Groundwater Transfer Review Summary Form

Transfer/PA # T- 14916

Application: T-14916

Applicant Name: Jensen Family, LLC

Application Map

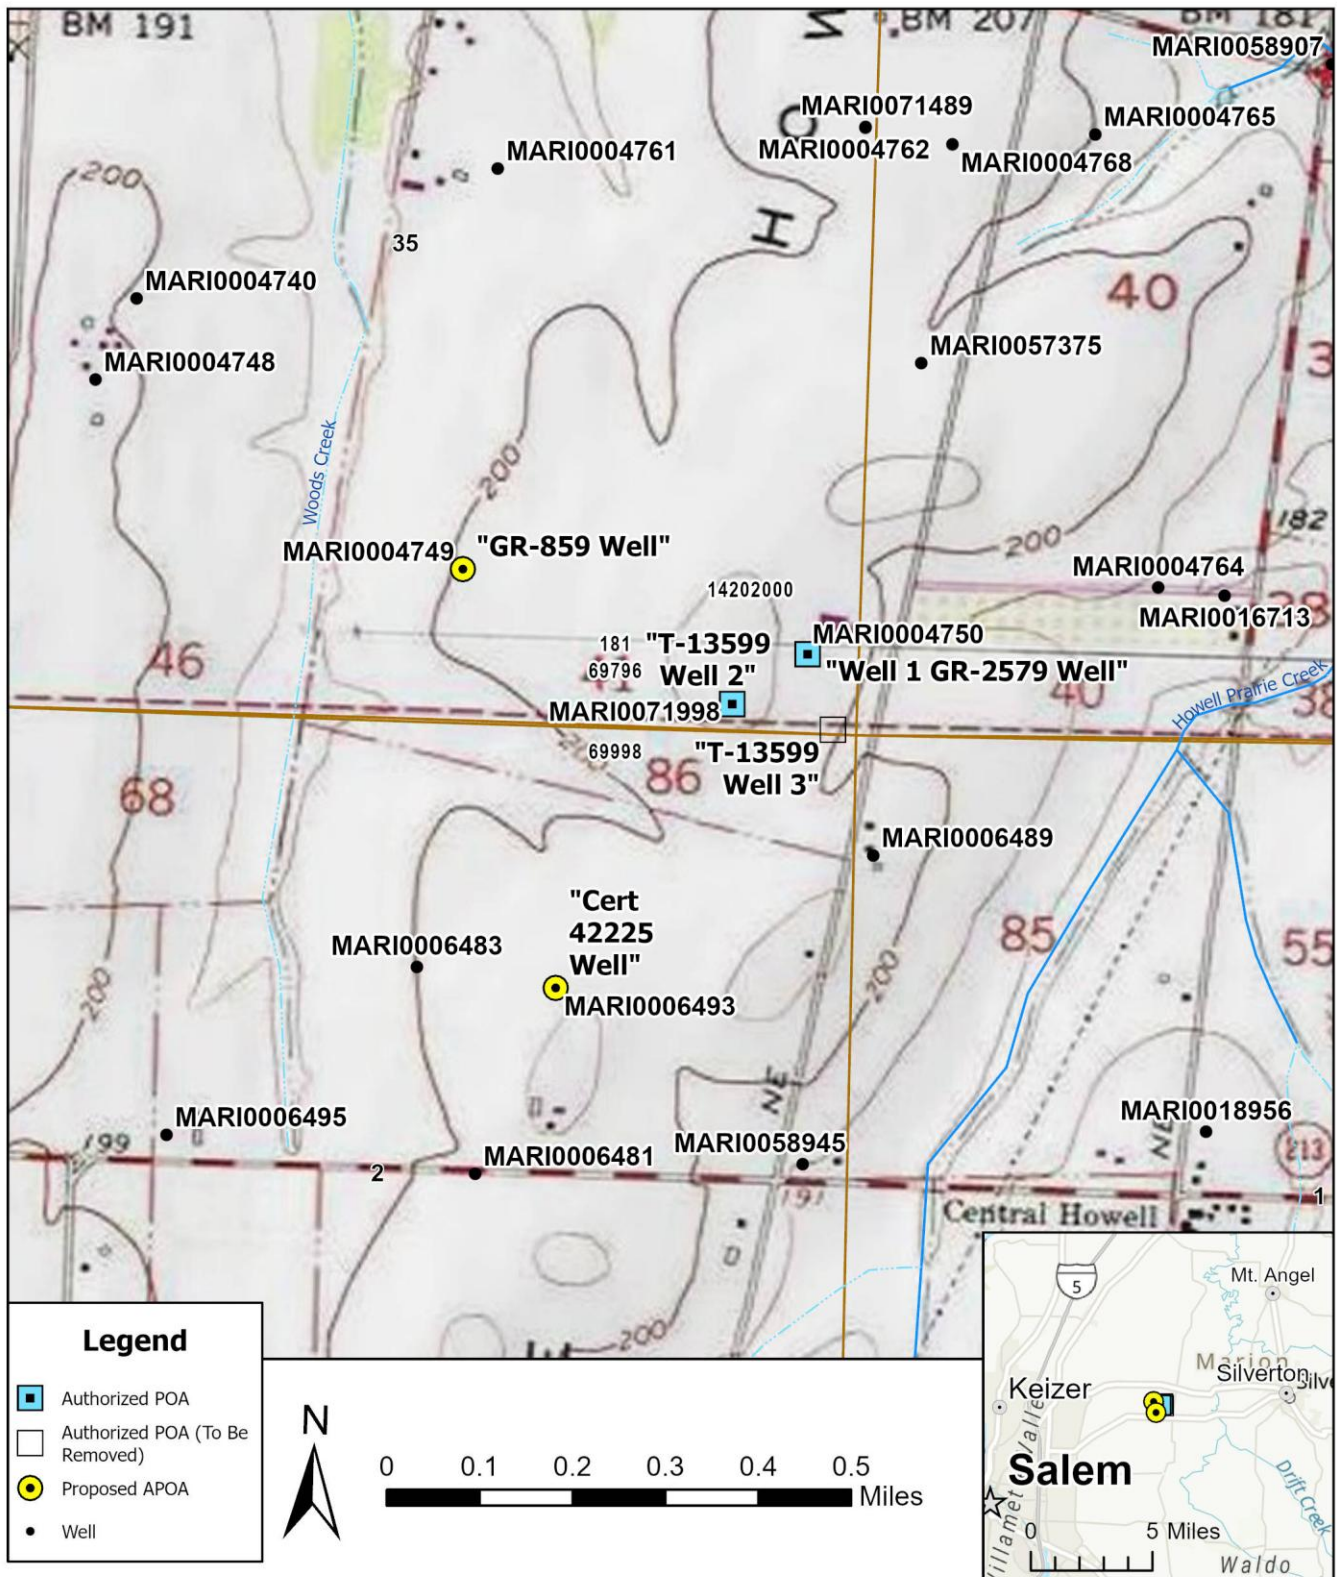
5. a) Will this proposed change, at its maximum allowed rate of use, likely result in an increase in interference with **another ground water right**?
☒ Yes ☐ No Comments: Neighboring well MARI 6483 (sole POA on Cert 62501) is ~800 ft west of the proposed APOA MARI 6493 and ~2,330 ft southwest of authorized POA MARI 71988. The closer proximity of the proposed APOA will likely increase interference with MARI 6483.

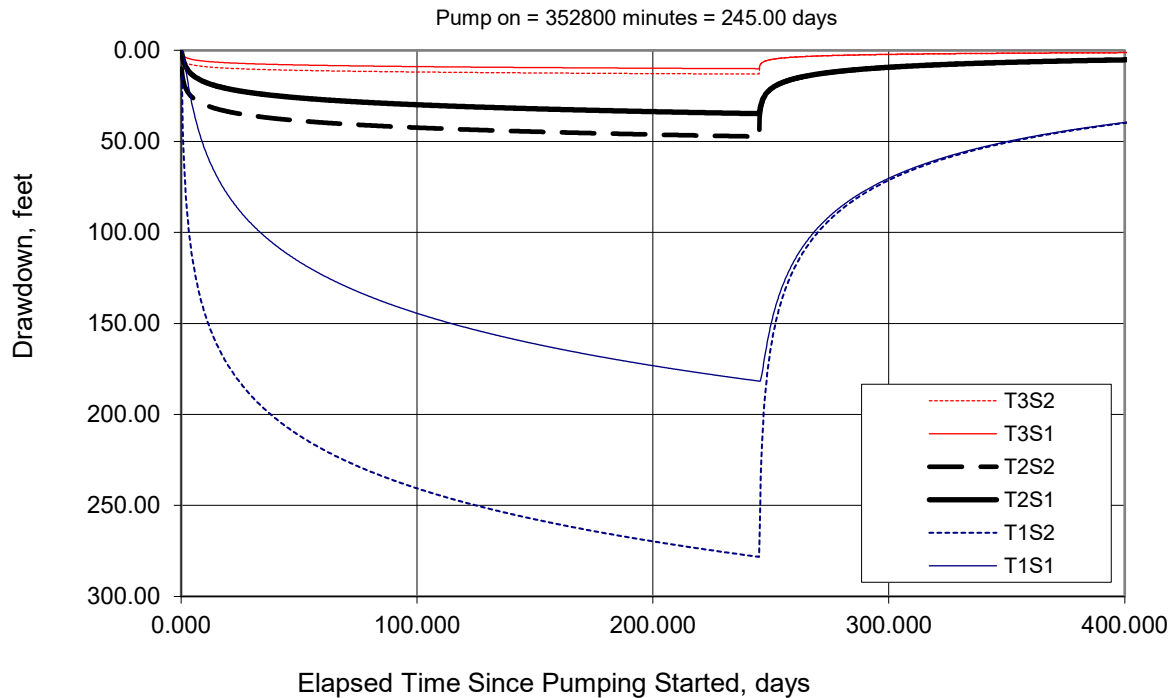
- b) If yes, would this proposed change, at its maximum allowed rate of use, likely result in another groundwater right not receiving the water to which it is legally entitled?
☐ Yes ☒ No If yes, explain: Potential interference with MARI 6483 was assessed using the Theis (1935) solution for drawdown in a confined aquifer (see attached Well Interference Analysis). Results of the analysis indicate that the proposed use is unlikely to result in injury to MARI 6483 or a similar neighboring use.

Well Interference Analysis, MARI 6493 (proposed APOA) to MARI 6483Theis Drawdown and Recovery at $r = 800$ ft From Pumping Well**Total pumping time, $t = 245$ days [Irrigation season]****Radial distance, $r = 800$ ft [approx. distance from MARI 6493 to MARI 6483]****Pumping rate, $Q = 1.591$ cfs [combined rate under GR-2579 and Inchoate T-14580]****Transmissivity: $T1 = 260$ ft²/day | $T2 = 2000$ ft²/day | $T3 = 8500$ ft²/day [pumping tests]****Storativity: $S1 = 0.003$ | $S2 = 0.0003$ [Conlon et al., 2005]****MARI 6483 (Cert 62501, 0.53 cfs, 1 POA)**

SWL	36 ft bls	Well log measurement
Well Bottom	197 ft bls	Well log
Available Drawdown	161 ft	Well Bottom - SWL
Pump Height Above Bottom	5 ft	Estimate
NPSHa	5 ft	Estimate
Estimated Drawdown	40 ft	@ 0.53 cfs (T2S2 parameters)
Minimum Water Column	50 ft	Estimated Drawdown + NPSHa + Pump Height
SUI	101 ft	Available Drawdown – Minimum Water Column
